Subject: AP1000 COL Standard Technical Report Submittal of APP-GW-GLN-019, Revision 1
(TR 103)

1. APP-GW-GLN-019, Revision 1, "Fluid System Changes," Technical Report Number 103

WESTINGHOUSE ELECTRIC COMPANY
AP1000 Licensing Design Change Document

Title: Fluid System Changes

Figure 5.1-1

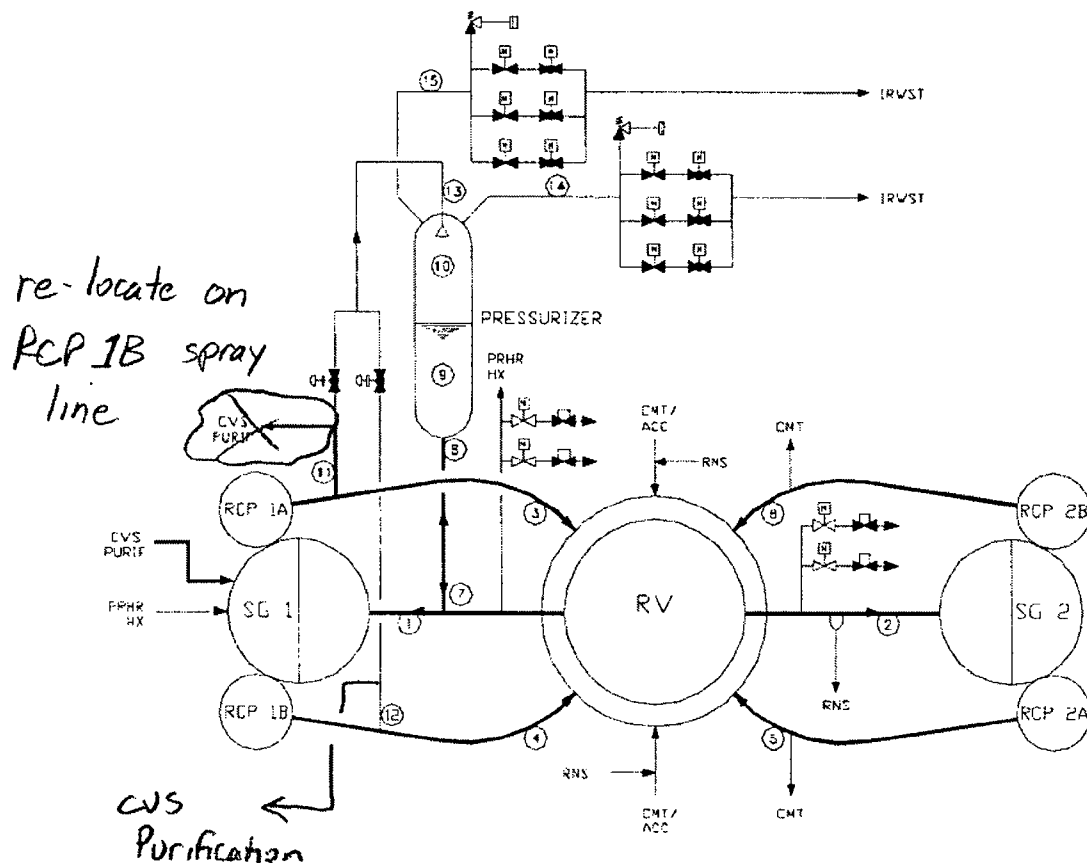
1. DCD Figure 5.1-1 (a simplified sketch of the RCS) incorrectly shows that the CVS purification system originates from cold leg 1A; it has been corrected to show that it originates from cold leg 1B.
2. RCS valve V241 normally closes on a high RCDT pressure signal from the PMS. The valve was a direct solenoid, normally open, fail closed valve. The valve has been changed to a fail closed AOV.

Figure 5.4-7
Revised RNS P&ID

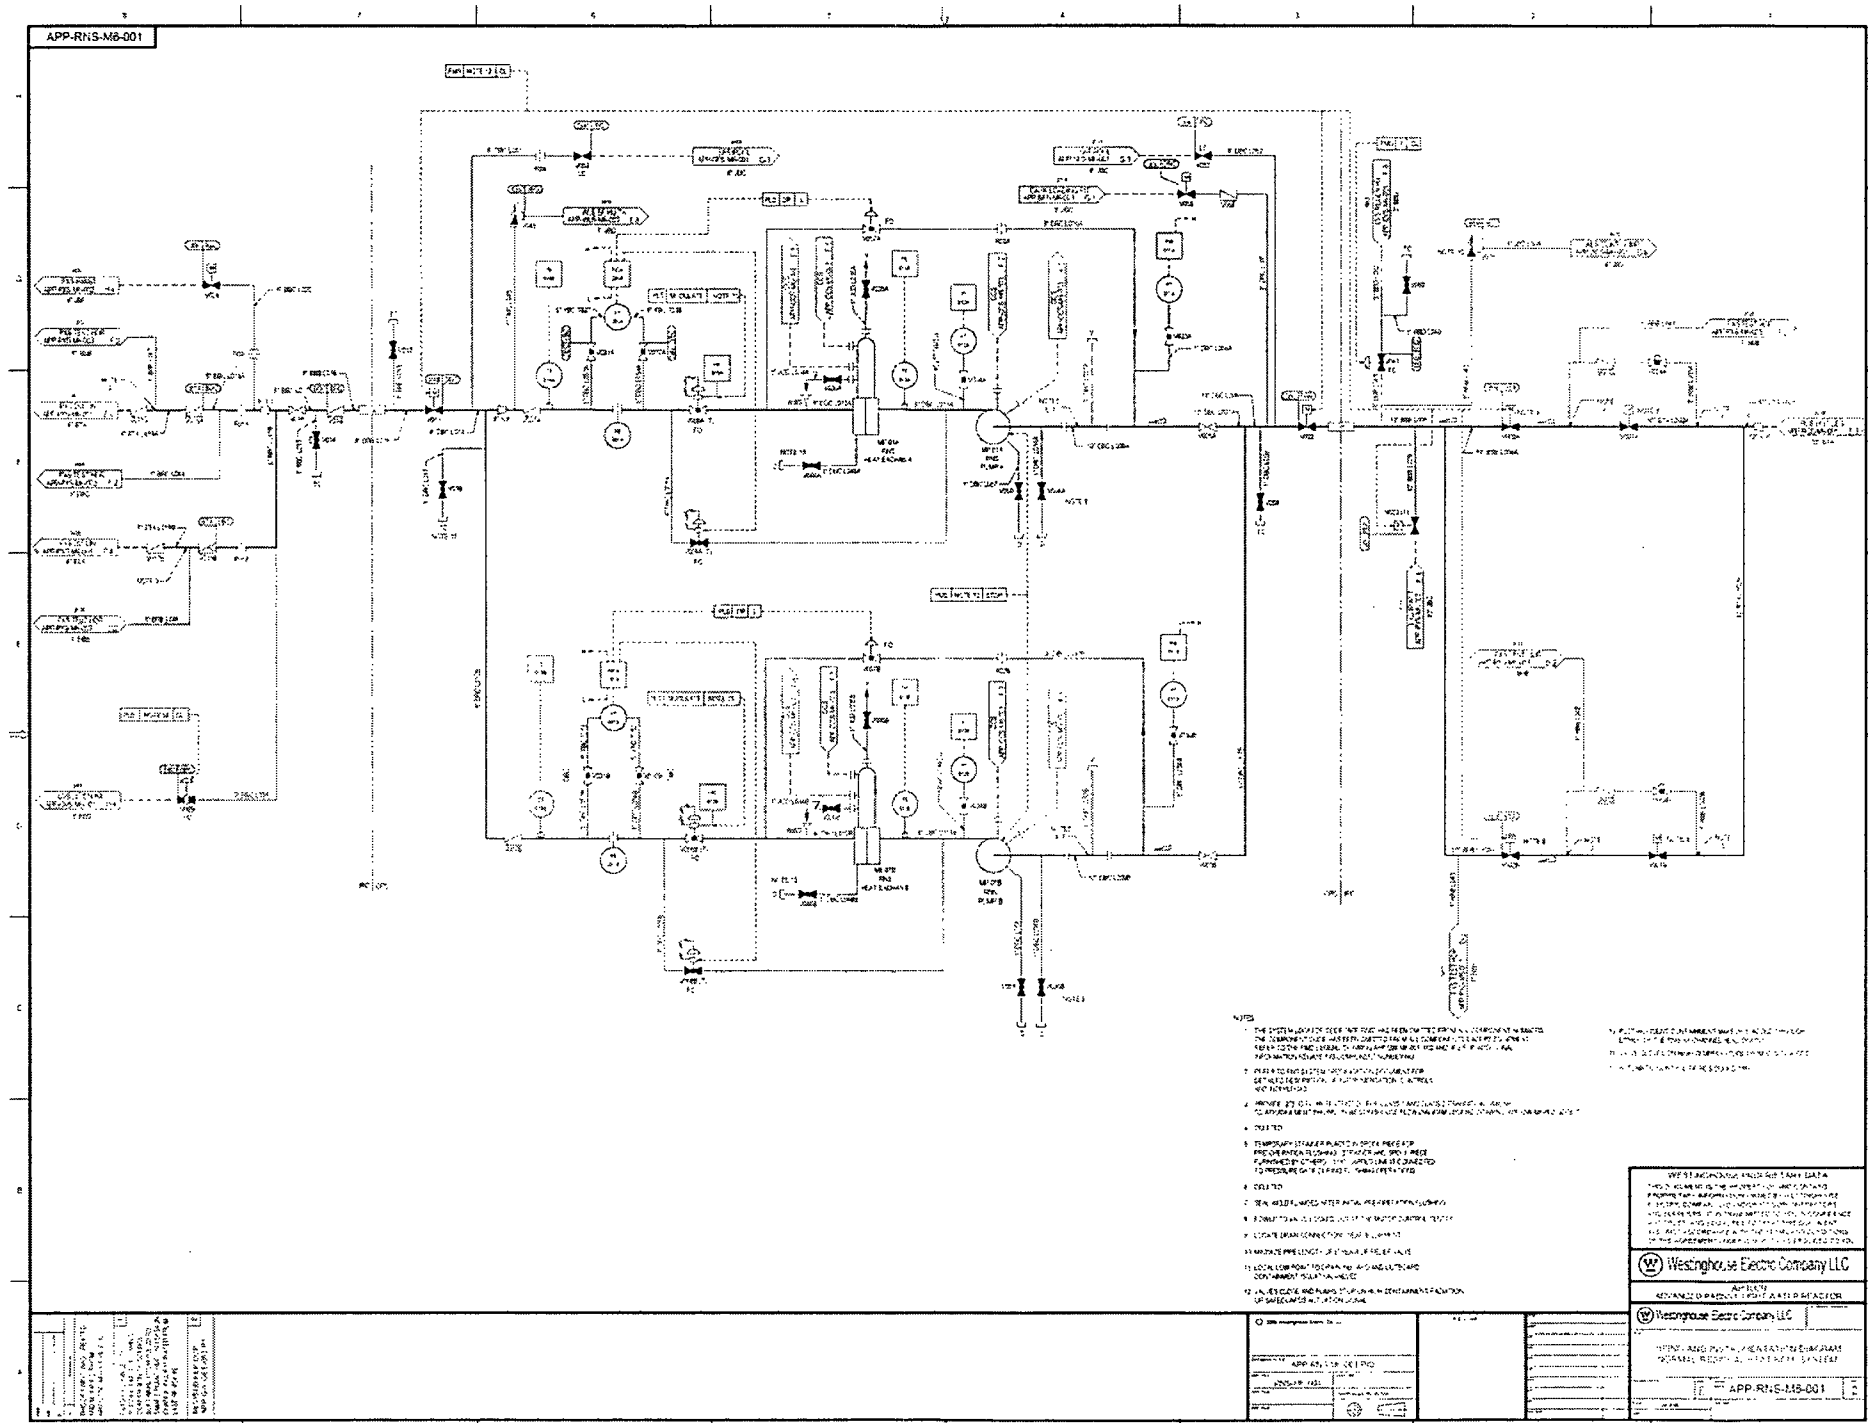
Figure 5.4-7 of the AP1000 DCD incorrectly shows the relief valve inlet size as 4" and the outlet size as 6". Figure 5.4-7 has been modified to reflect the current RNS P&ID which represents the relief valve inlet size as 3" and the outlet size as 4".
